PLANS

STATE OF NEW YORK
DEPARTMENT OF TRANSPORTATION
DESIGN AND CONSTRUCTION DIVISION
PLANS FOR CONSTRUCTING THE
EUCLID - NORTH SYRACUSE HIGHWAY

Field Change Sheets:
3F1, 5F1, 53F1, 12F1, 13F1, 13F2, 134F1, 135F1, 136F1, 137F1, 138F1, 139F1, 100F1, 101F1, 102F1, 103F1, 104F1, 105F1, 106F1, 108F1, 117F1, 119F1

As Built Revisions by Francis H. Backus
Approved: Eugene Parous, Asst. Contr. Supervisor, 3-27-1973
P.E. License No. 37013

EUCLID-NORTH SYRACUSE, S.M.
AS BUILT
 FIELD CHANGE SHEETS

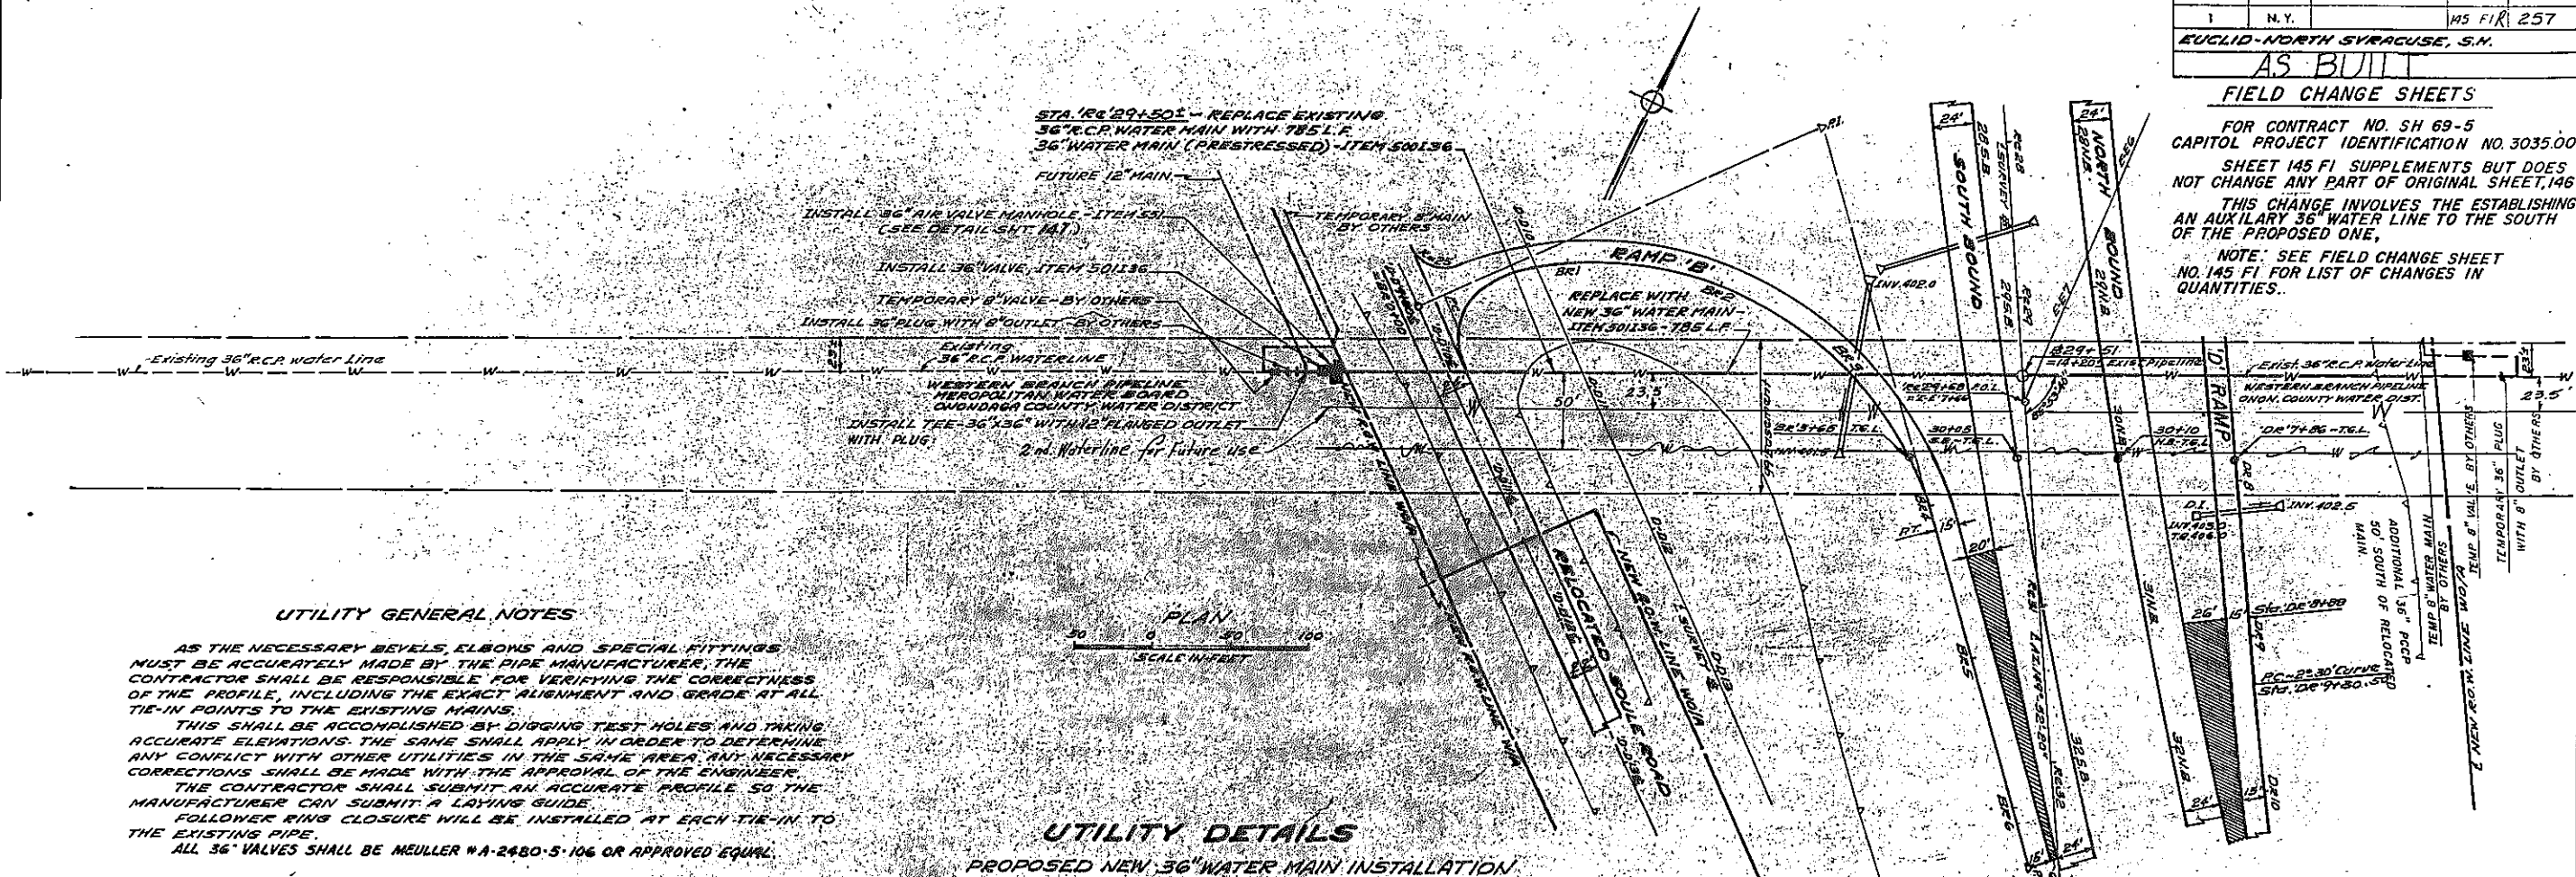
FOR CONTRACT NO. SH 69-5
 CAPITOL PROJECT IDENTIFICATION NO. 3035.00
 SHEET 145 FI SUPPLEMENTS BUT DOES NOT CHANGE ANY PART OF ORIGINAL SHEET, 146
 THIS CHANGE INVOLVES THE ESTABLISHING AN AUXILIARY 36" WATER LINE TO THE SOUTH OF THE PROPOSED ONE.
 NOTE: SEE FIELD CHANGE SHEET NO. 145 FI FOR LIST OF CHANGES IN QUANTITIES.
